ADDENDUM NO. 2

**Three Rivers Community Schools – Three Rivers Middle School Additions and
Renovation**

SHEET CLARIFICATIONS / REVISIONS

UNIT 'A' ROOF FRAMING PLAN
1/8" = 1'-0"

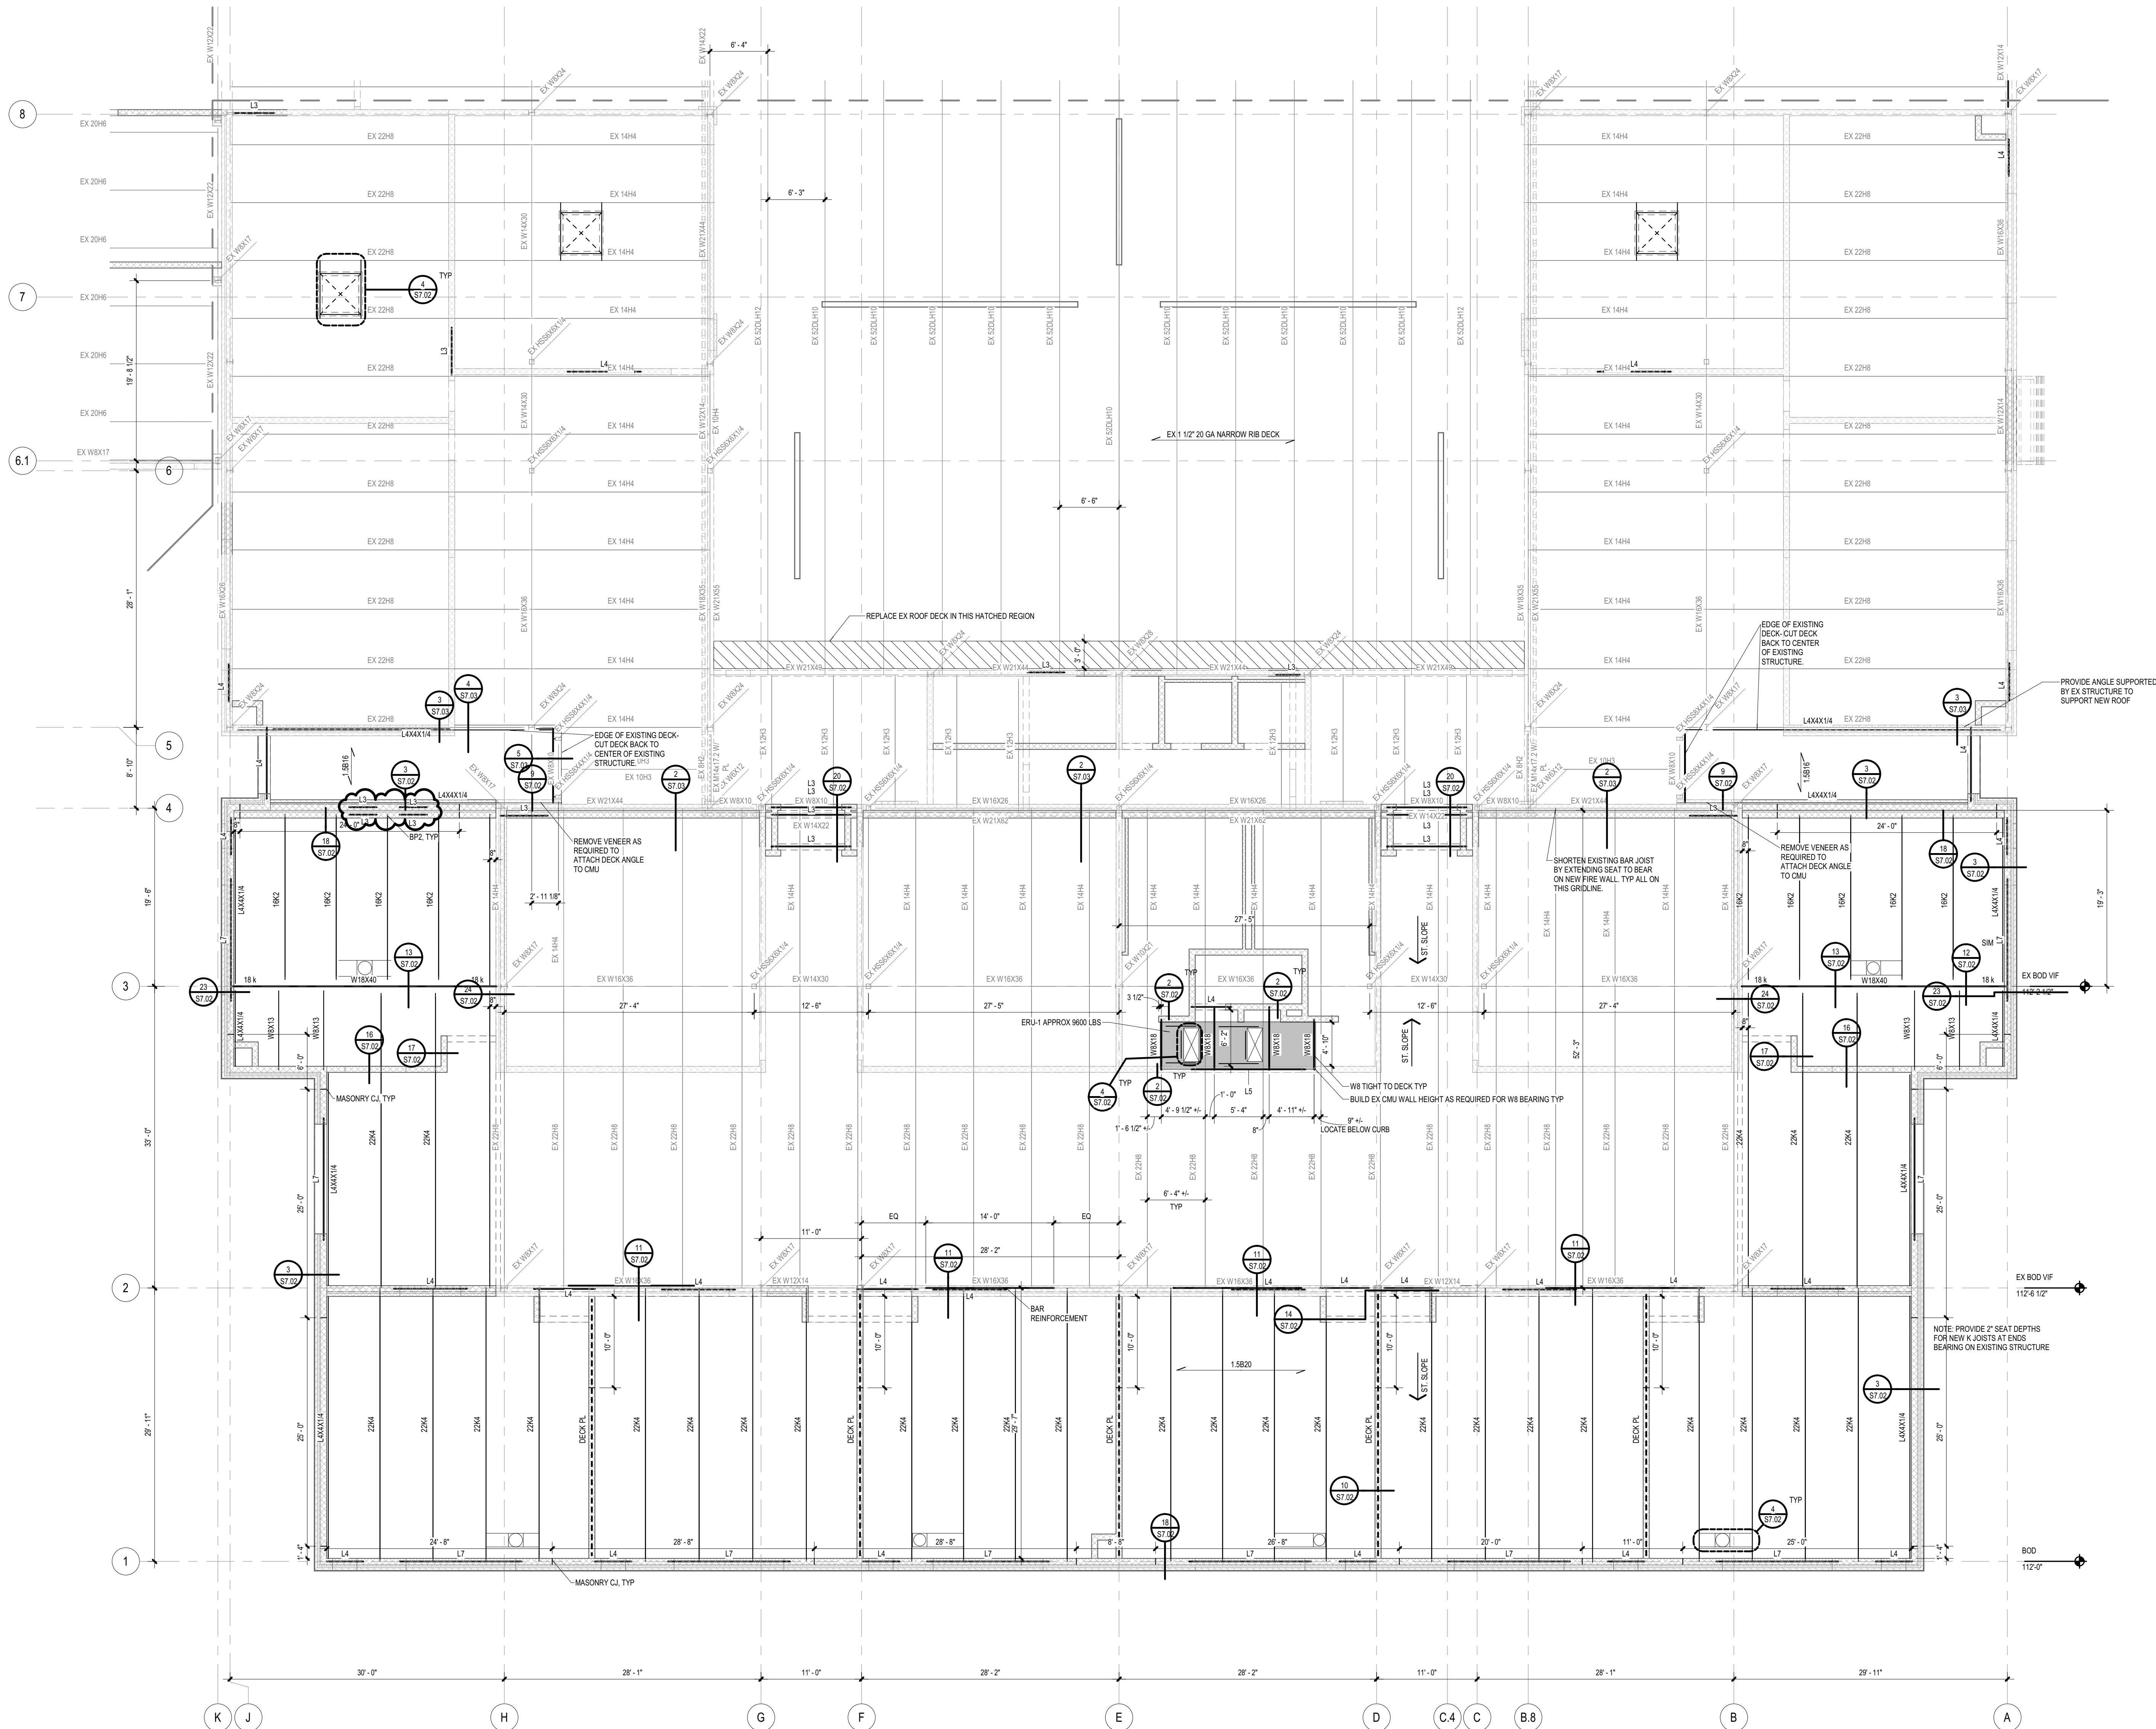
ITEM NO. 11 SHEET S3.1A – UNIT ‘A’ ROOF FRAMING PLAN (REISSUED)

Added lintels per ductwork update.

UNIT 'C' FIRST FLOOR PLAN
1/8" = 1'-0"

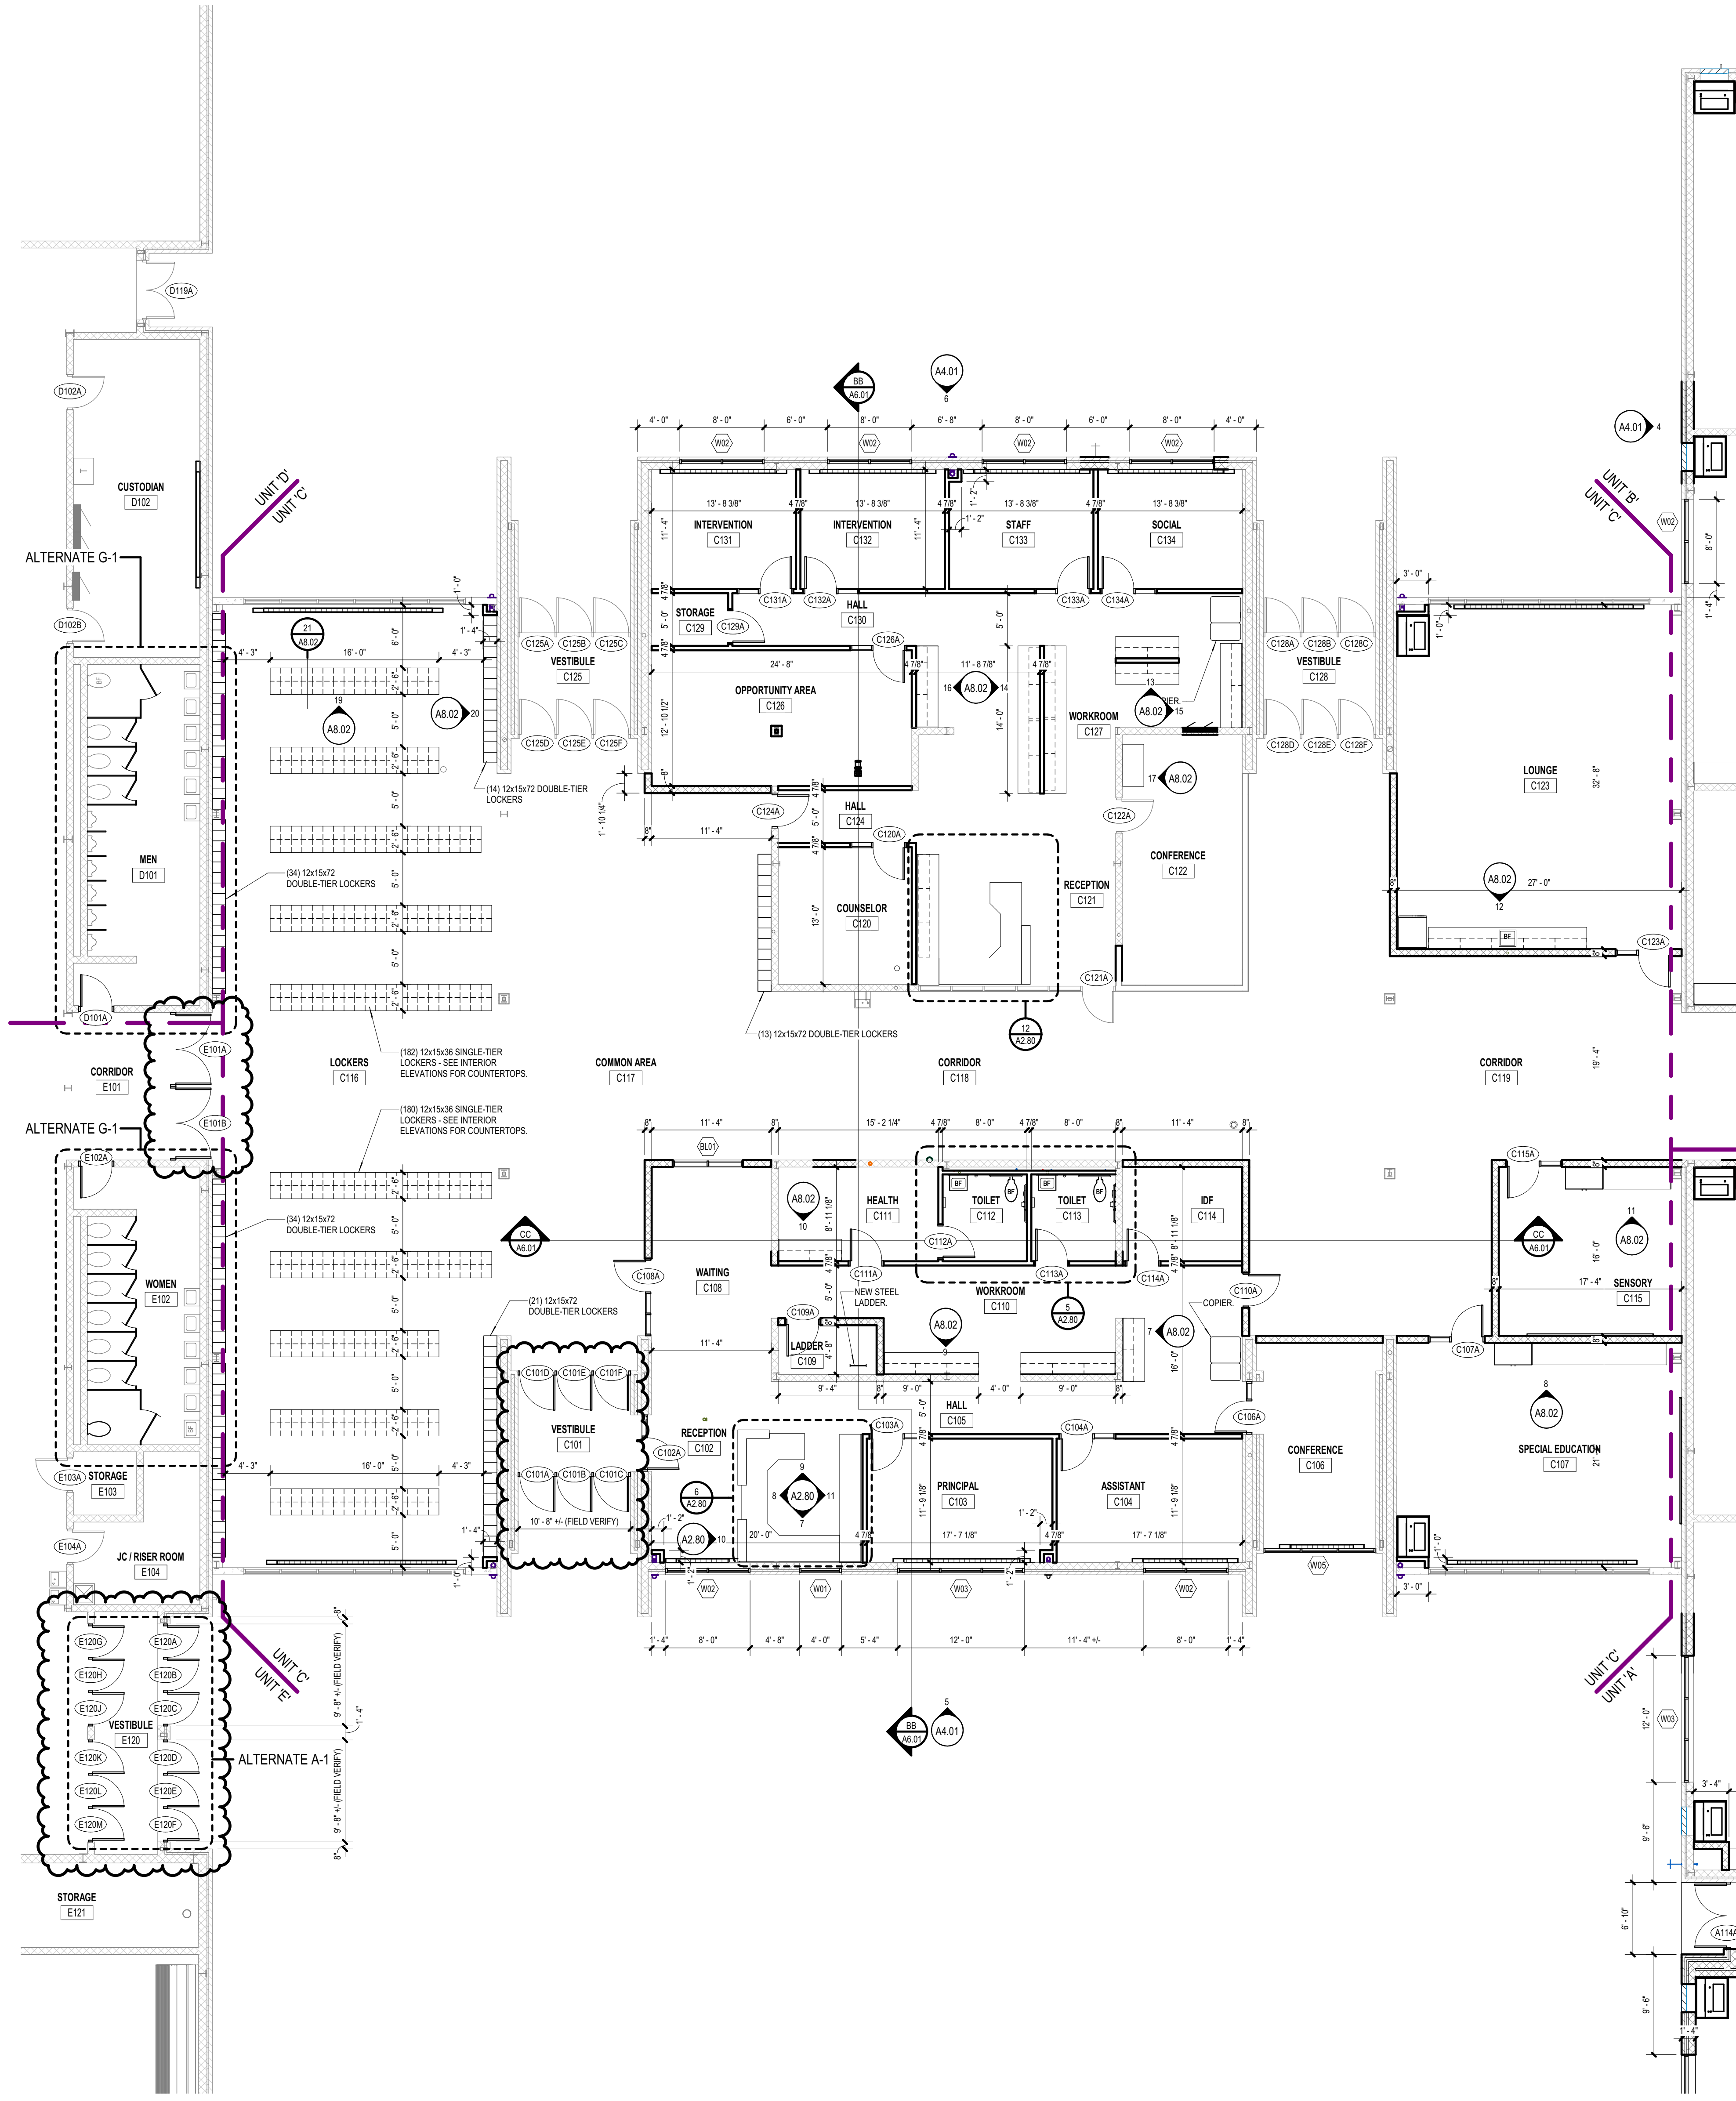
ITEM NO. 19 SHEET A2.1C – UNIT ‘C’ FIRST FLOOR PLAN (REISSUED)

- A. Added new doors and frames at Vestibule C101.
- B. Added new doors and frames at Vestibule E120.

UNIT 'E' FIRST FLOOR PLAN
1/8" = 1'-0"

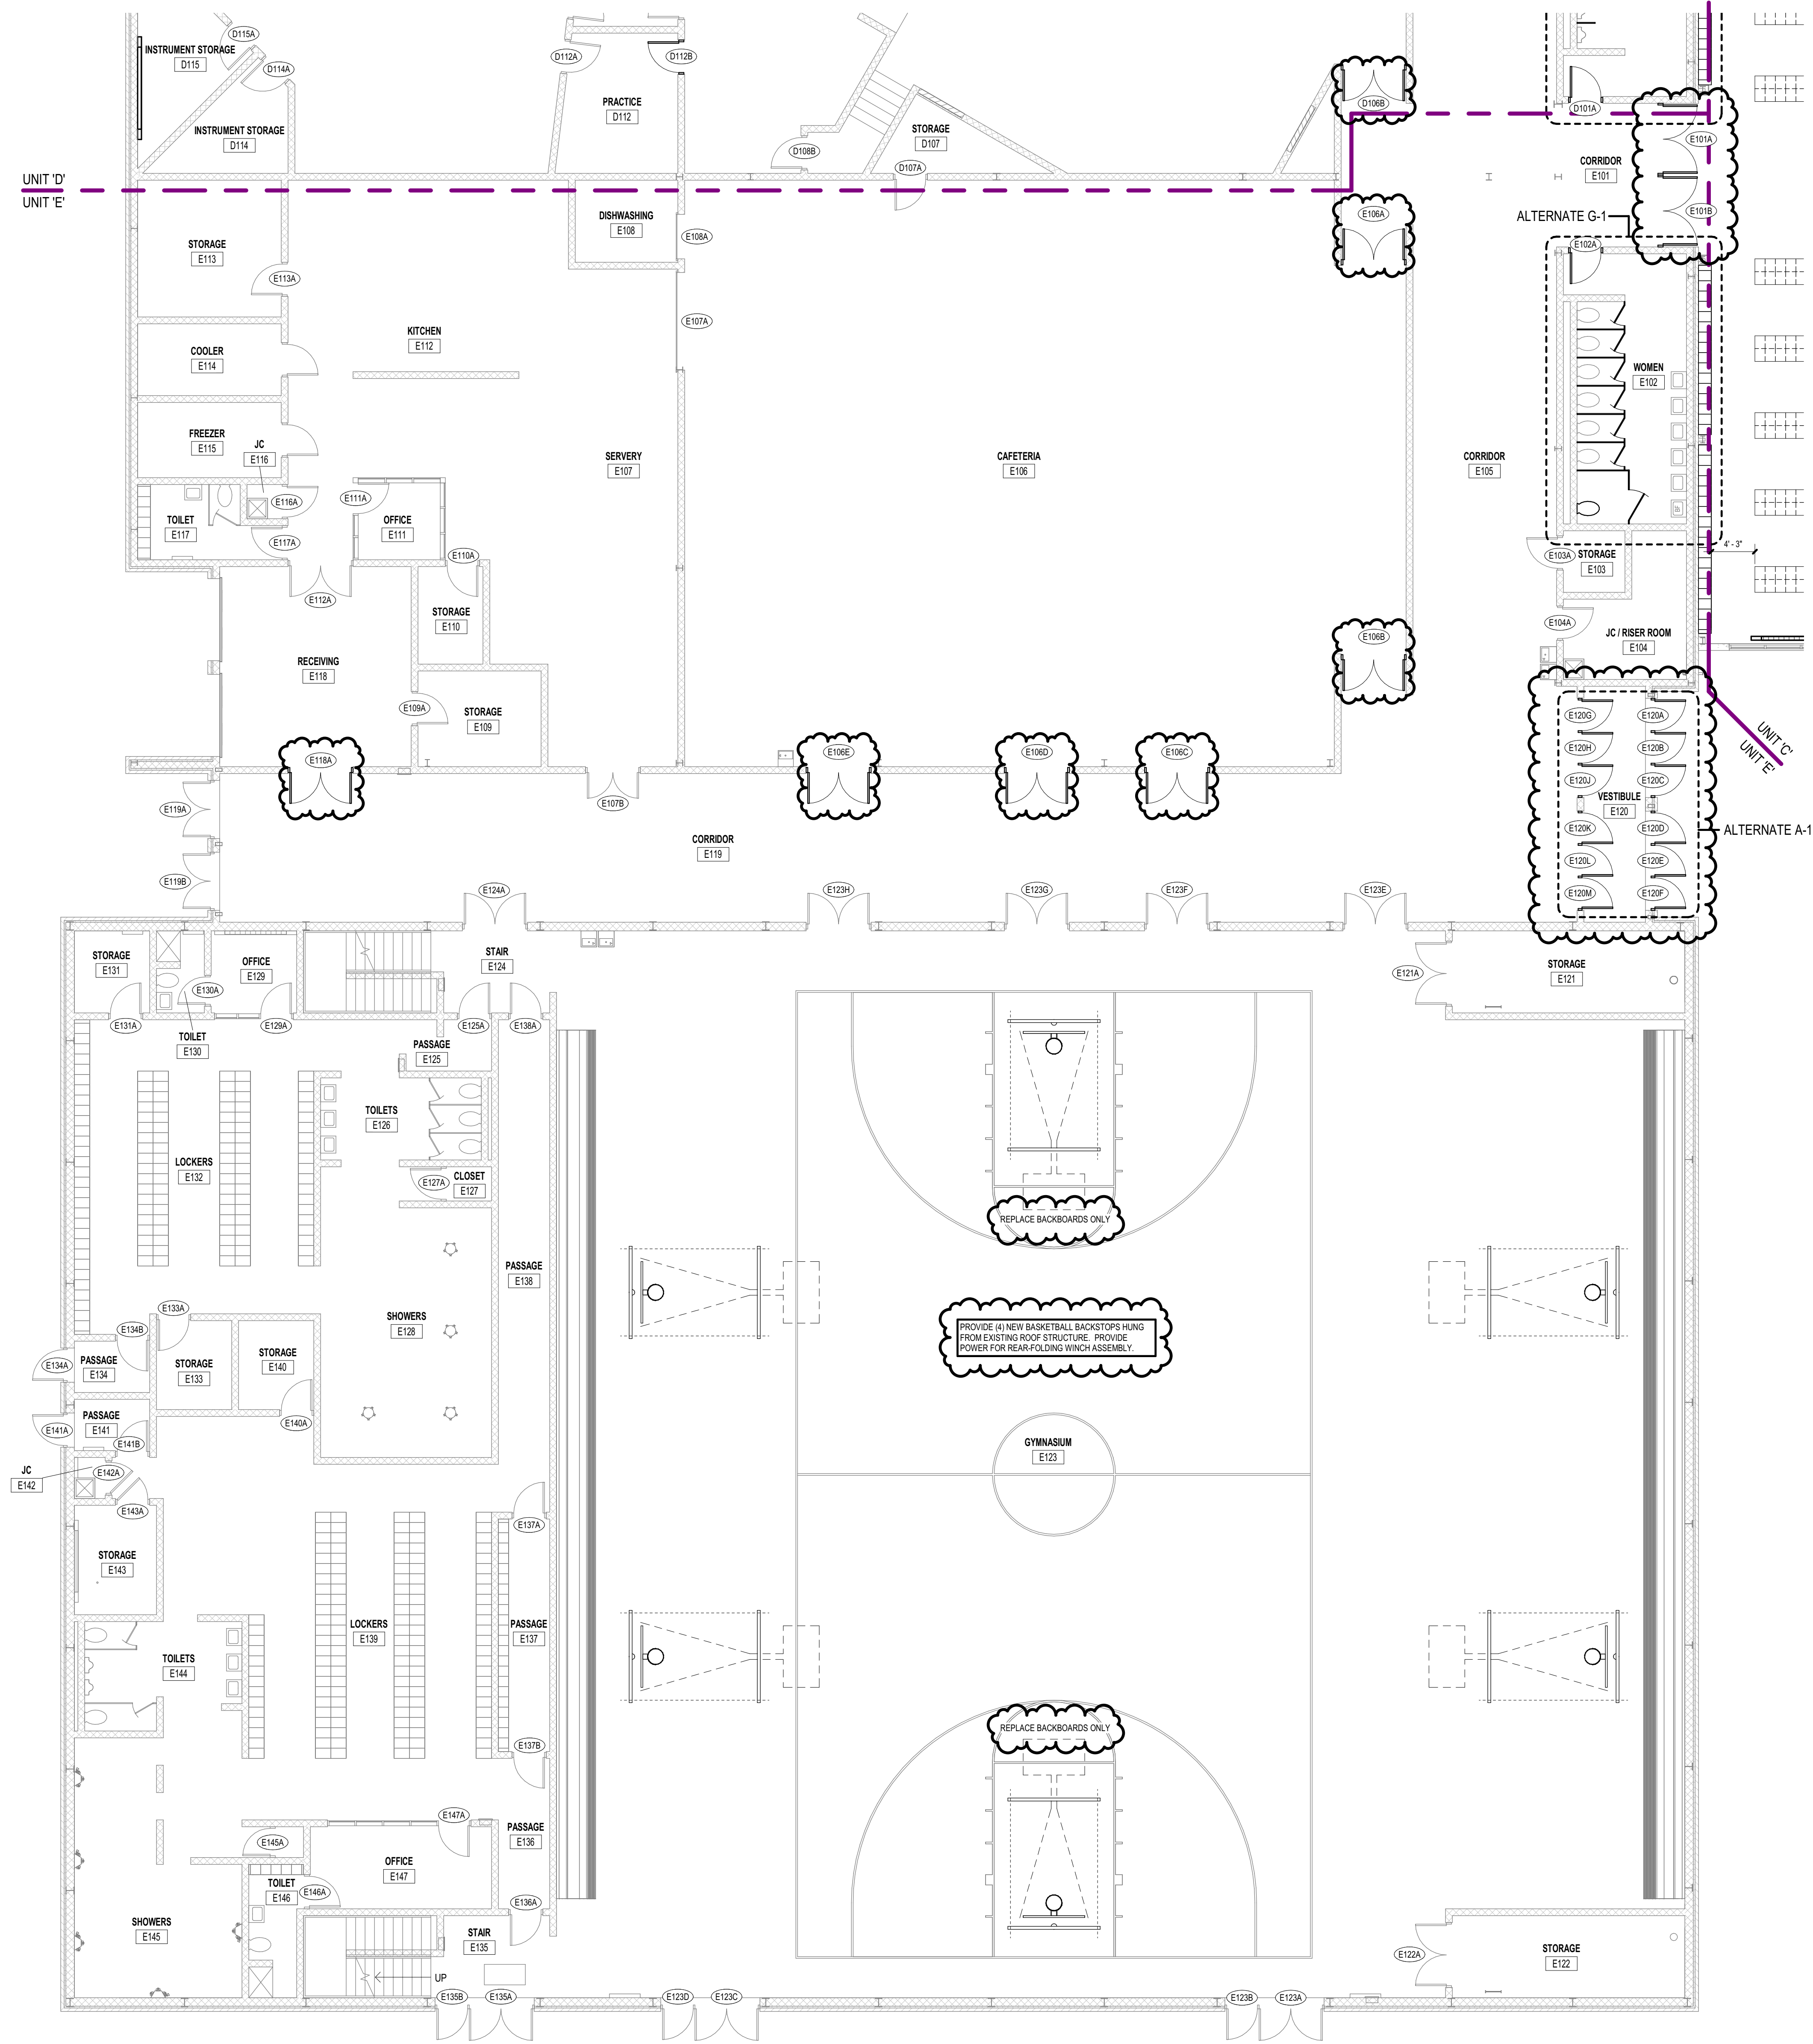
ITEM NO. 21 SHEET A2.1E – UNIT ‘E’ FIRST FLOOR PLAN (REISSUED)

- A. Added new door E118A into existing frame.
- B. Added new doors and frames at Vestibule E120.
- C. Added new doors E106A-E106E into existing frames.
- D. Added new doors E101A and E101B into existing frames.
- E. Revised backstop replacement notes as shown clouded.
